MEMORANDUM

From:	Catherine Brimble Senior Landscape Officer		
Service	SDL Landscape and Trees	App No:	241962
Address:	Hogwood Farm, Sheerlands Road, Arborfield, Wokingham, RG40 4QY.		
Proposal:	Application for approval of Reserved Matters pursuant to Outline Planning Consent O/2014/2179 (as varied by 181194, dated 14/11/2018). The Reserved Matters comprise details of 18 no. dwellings, commercial floorspace (Use Class E) and public open space within the Neighbourhood Centre parcel together with associated access, parking, drainage and play infrastructure. Details of access, appearance, landscaping, layout and scale to be considered.		
Type of Development:	Major Dwellings (10+)		
Site Visit Made:	Yes/No

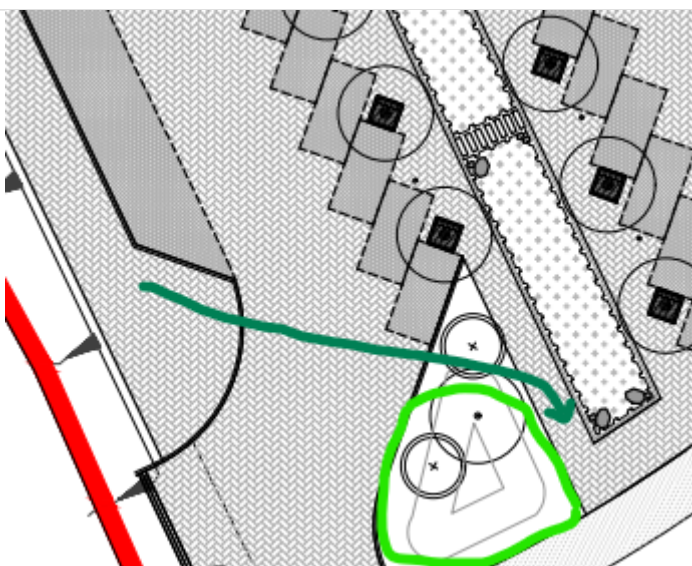
8. Pedestrian access into the plaza area from the north-east crossing by the roundabout is blocked by a planting bed. Part of which should be removed to allow a more direct route which people are likely to take anyway. See extract below showing the likely desire line. However, if the planting bed is located in this area to accommodate a change in level then this won't be such an issue, but as previously stated it is not clear what the levels are in this area.

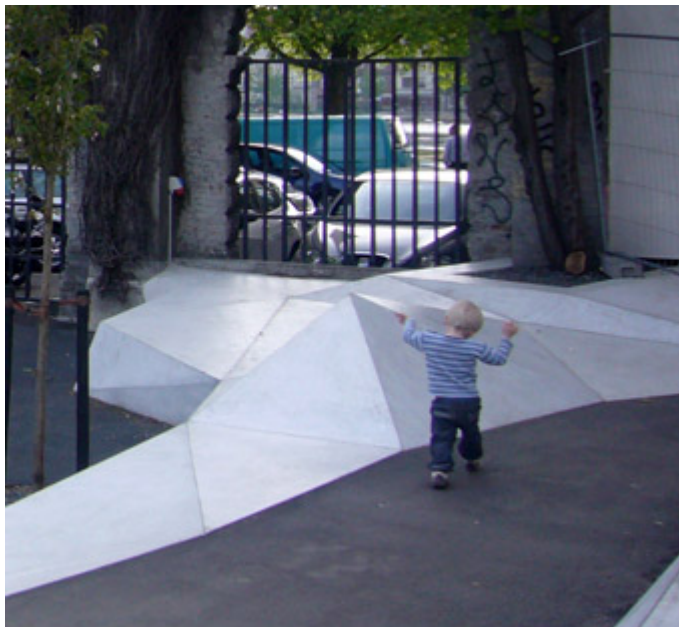
18. The play space is disappointing in terms of its form and equipment provided and seems incongruous for its location in a central urban square. The main element of the LAP is shown with two trampolines and a small slide which I consider to be uninspiring. A better use of space would be to include more ambiguous elements that could be used in a number of different ways and encourage children to use their imagination but also help to define the space. This could be achieved by mounding incorporating play elements such as stepping stones, bridges etc, integrated seating, platforms or sculptural forms that can be sat on climbed on. I have included a number of images below to show the type of elements that could be used in this area but adjusted to fit the space.
